N5998A-02

S E R V I C E N O T E

N5998A: HDMI 1.3 Protocol Analyzer and Generator

Serial Numbers: DE47300001/DE47300188

Figure 1

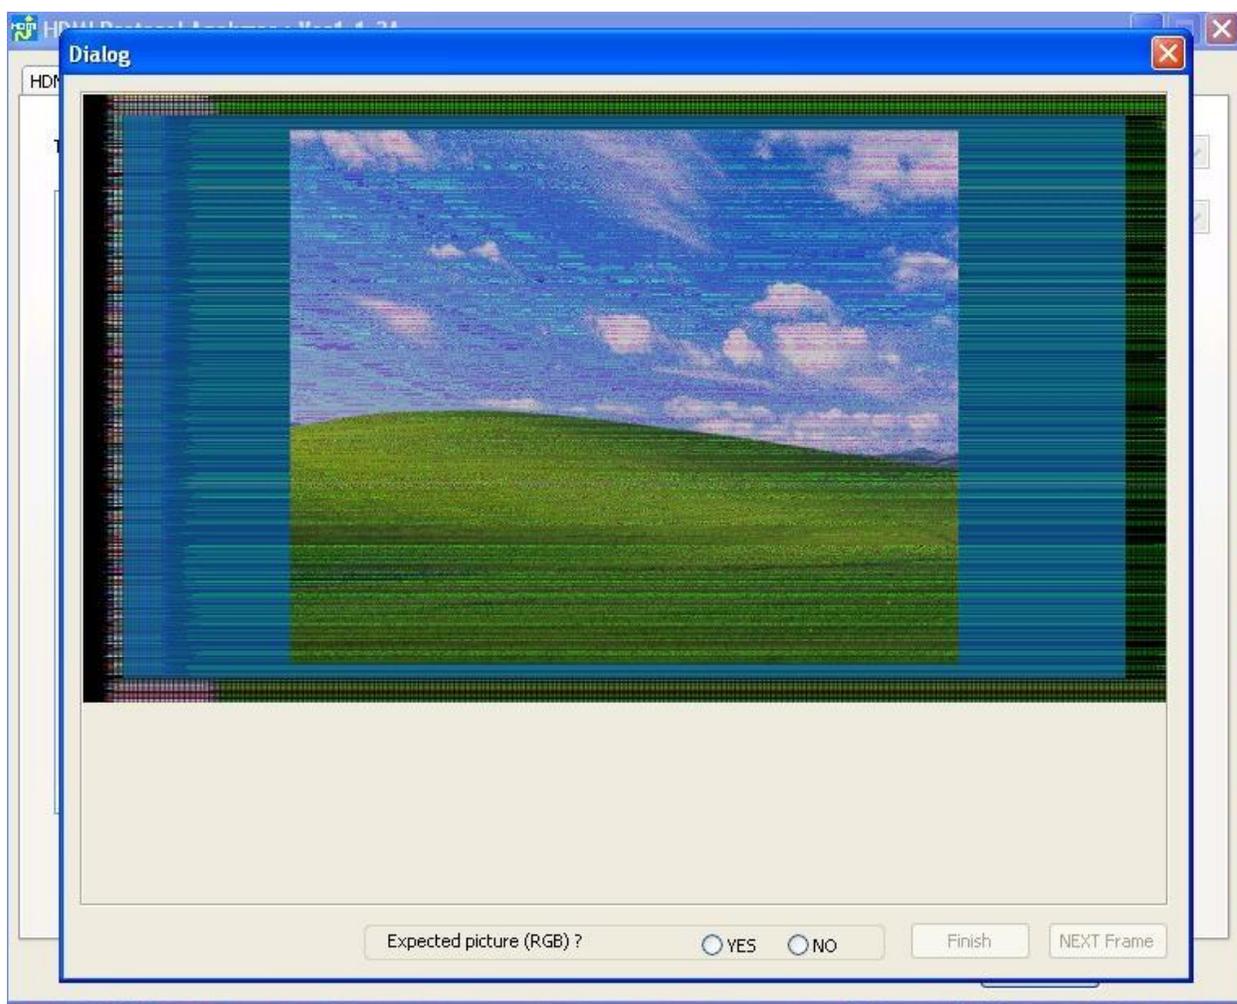
When capturing HDMI 1.3 1080p video frames with the N5998A, the instrument does not capture the frames correctly in all cases. If frames from specific DUTs are captured, pixel errors might occur. An illustration of these pixel errors is shown in figure 1 below:

As a consequence of these pixel errors, the following HDMI 1.3 compliance tests specified in the HDMI 1.3b CTS might fail: 7-16, 7-17, 7-24 and 7-25.

Figure 9

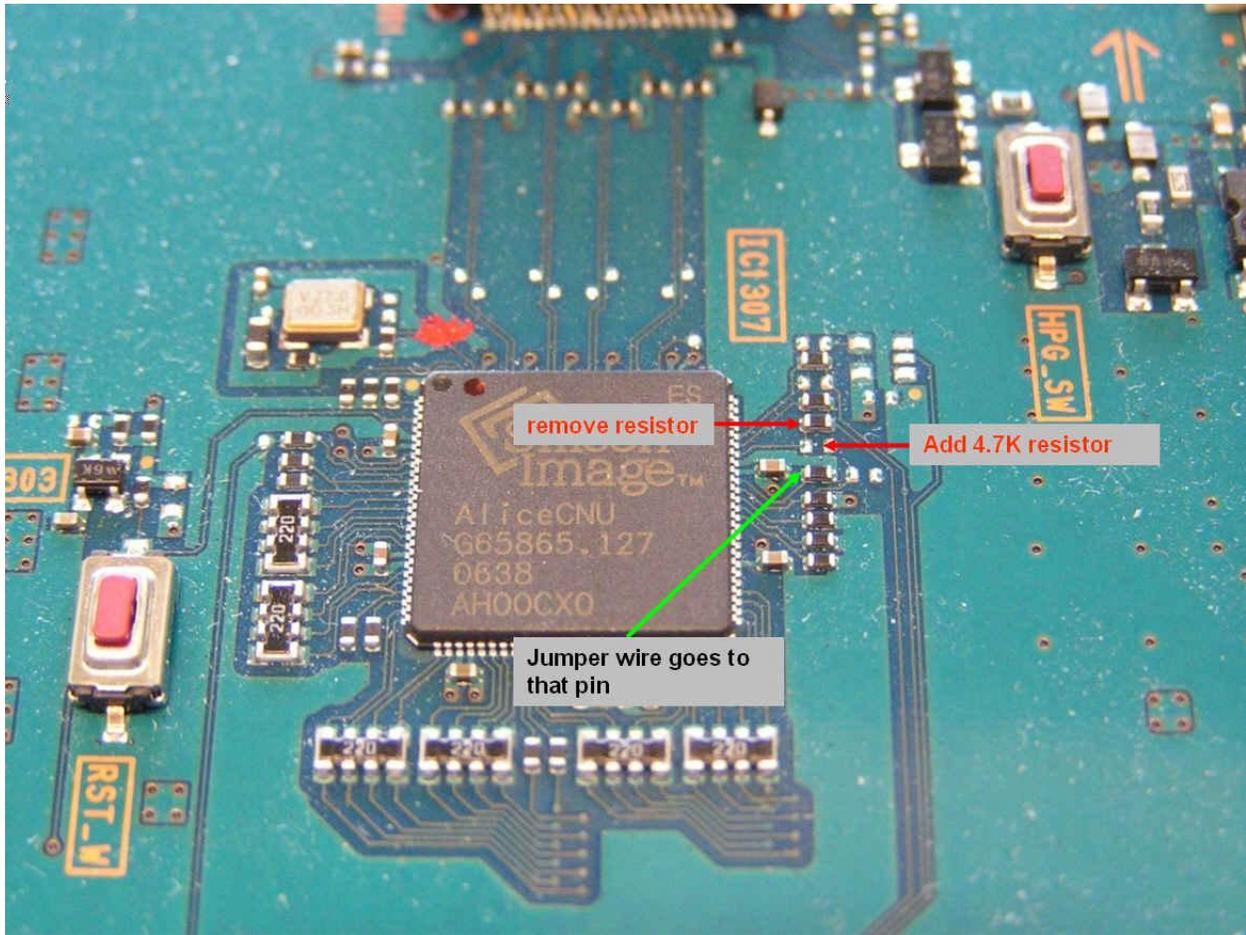
6. The following modifications need to be made near the Silicon Image Receiver Chip:

Figure 10

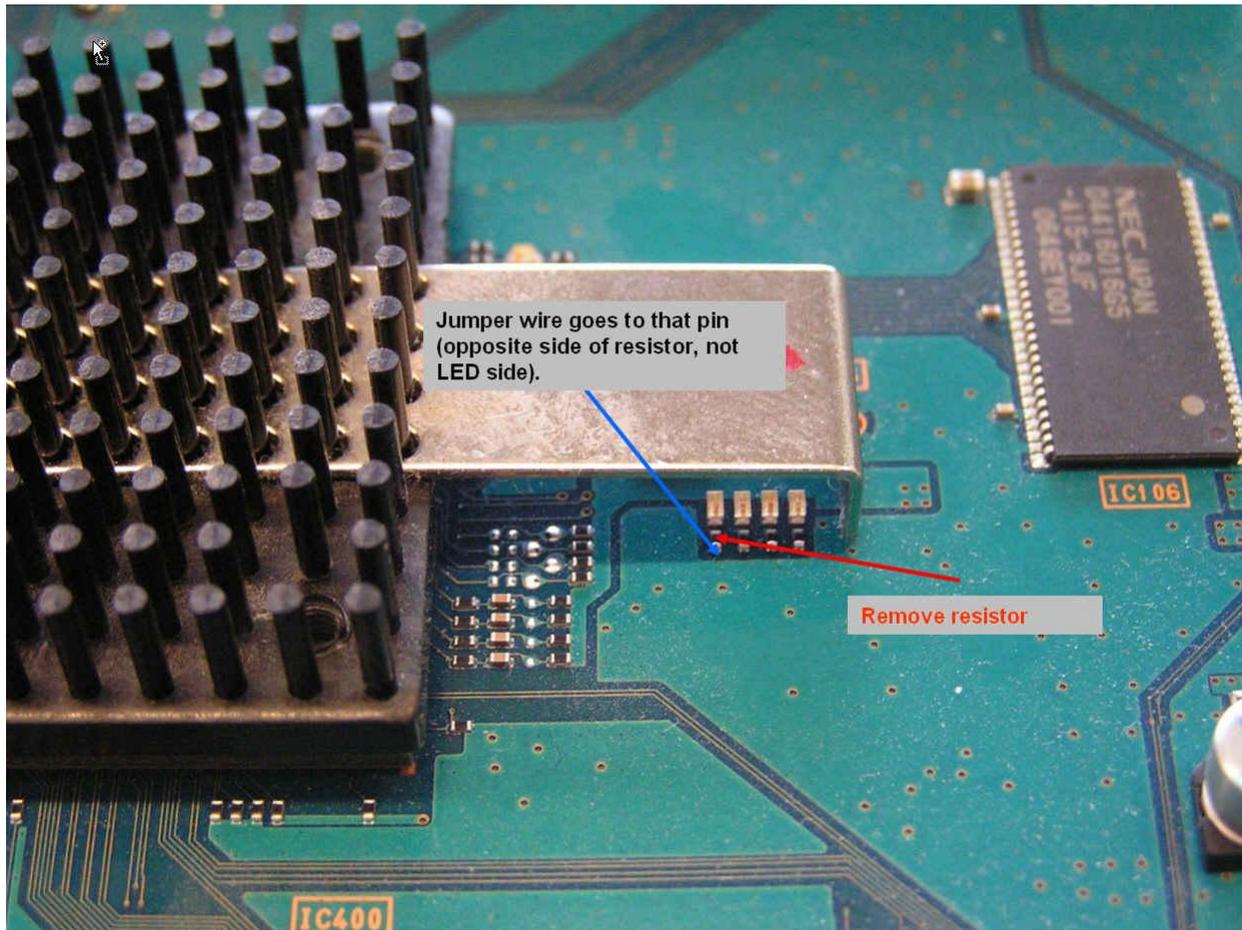
7. Near the FPGA one resistor needs to be removed and the other side of the jumper wire needs to be connected:

Now glue the jumper wire to the PCB board using appropriate epoxy.

Figure 11

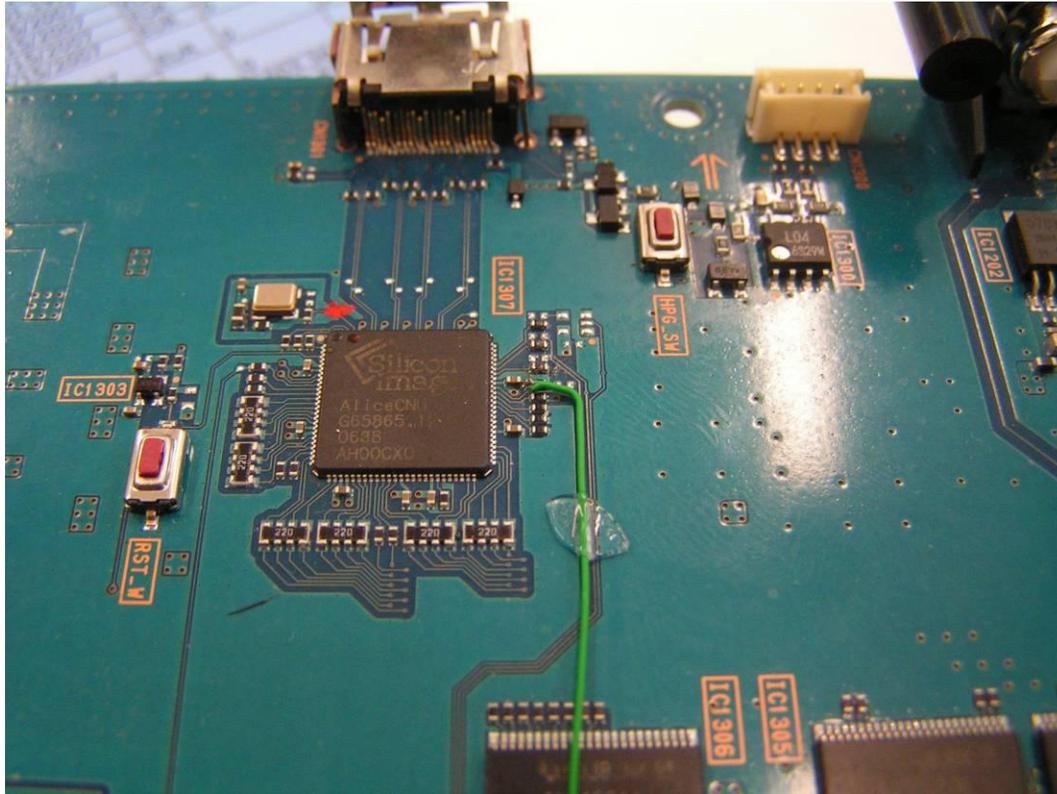
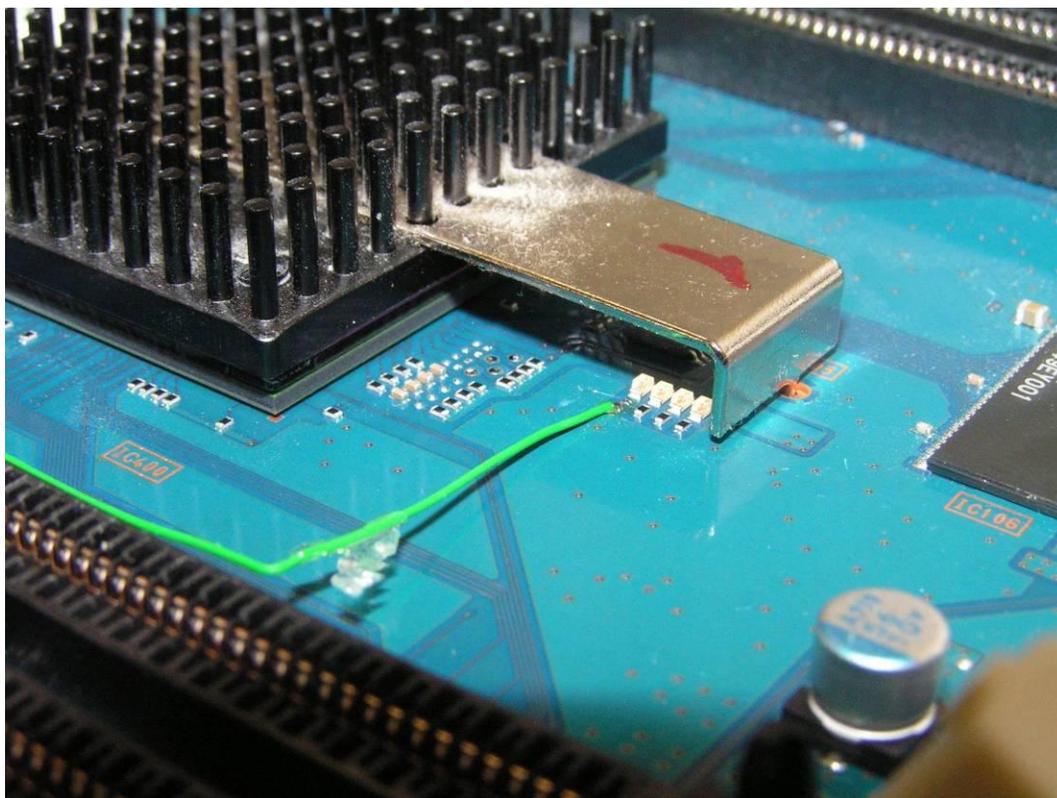
This is how the board should look like after the modifications:
